# **AGENDA FOR THE CANTERBURY BANKSTOWN LOCAL PLANNING PANEL MEETING**

**9 October 2023 - 6.00 PM**

#### **1        31/177 Banksia Road, Greenacre**

Demolition of existing buildings on Strata Lot 31 in SP 88998 and construction of a residential flat building development comprising 71 apartments (55 x 2-bed units and 16 x 3-bed units) ranging in height from 3-6 storeys with basement car parking, and with strata subdivision.

**Figure 8 – Reproduction of ‘Figure 43’ from Part A2 of the BDCP 2015**

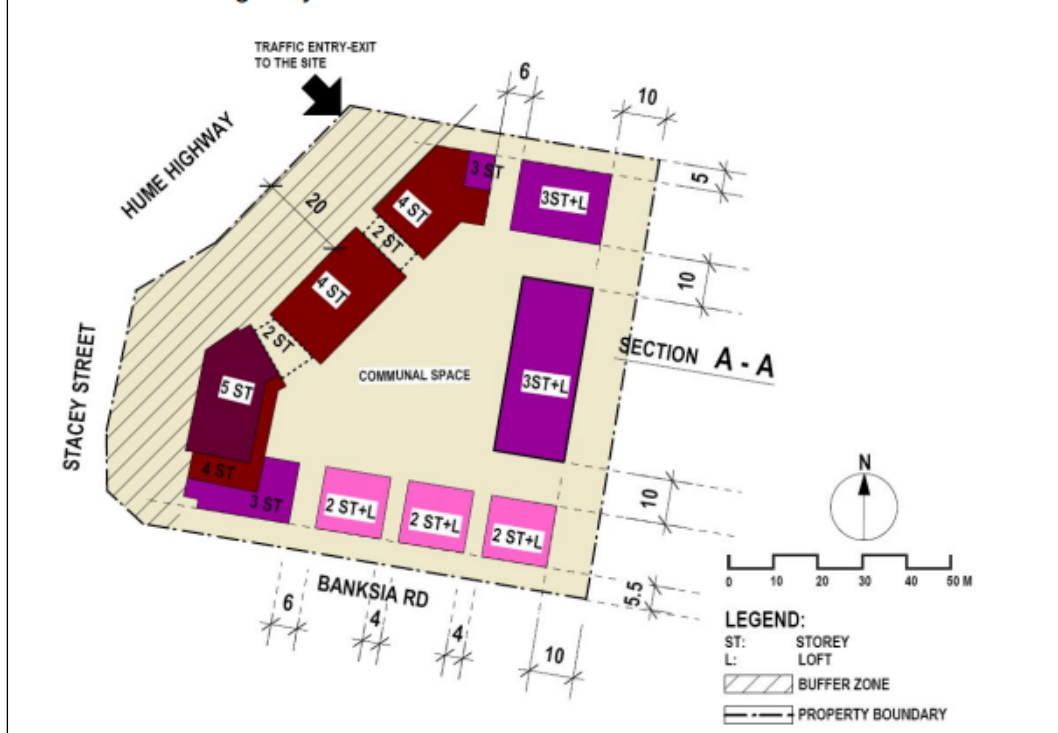
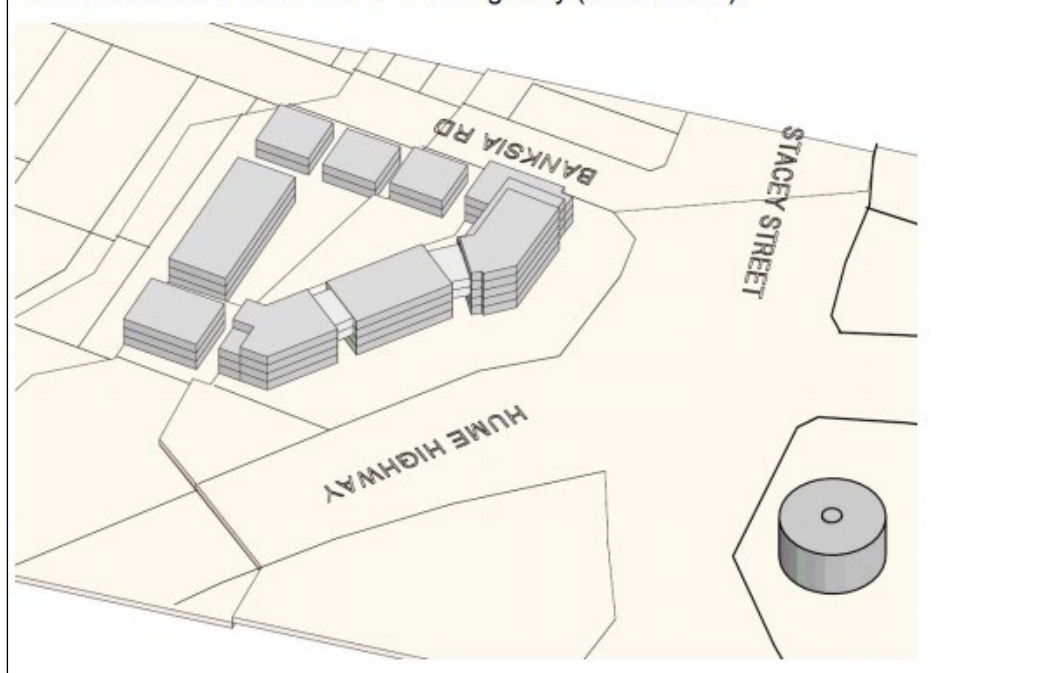
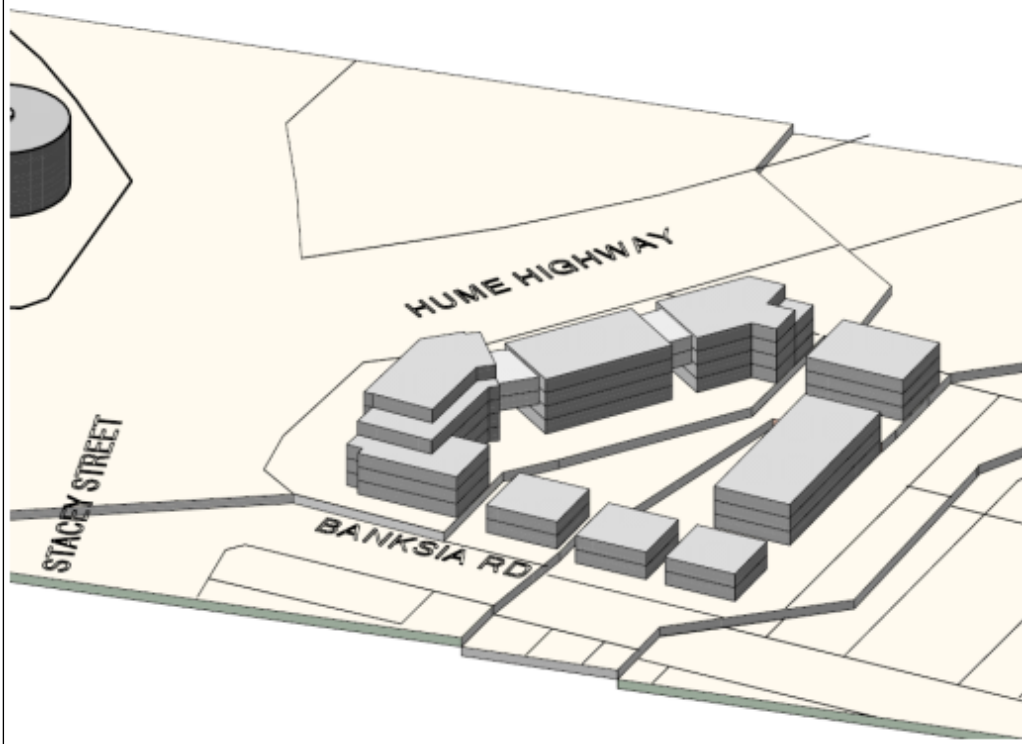
The BDCP 2015 controls envisage vehicular access from the Hume Hwy, to minimise the impact of vehicular movements onto a site zoned B6 – Enterprise Corridor, especially from Banksia Rd which is zoned R2 – Low density residential like the remaining sites with access to Banksia Rd. As detailed above, when referred to TfNSW, it was reiterated that the Transport and Infrastructure SEPP envisages minimal vehicle access to and from classified roads. In this instance, the SEPP overrides the DCP control. Given this, Clause 6.13(b) and 6.19 do not apply to the proposed development, as the SEPP takes precedence.
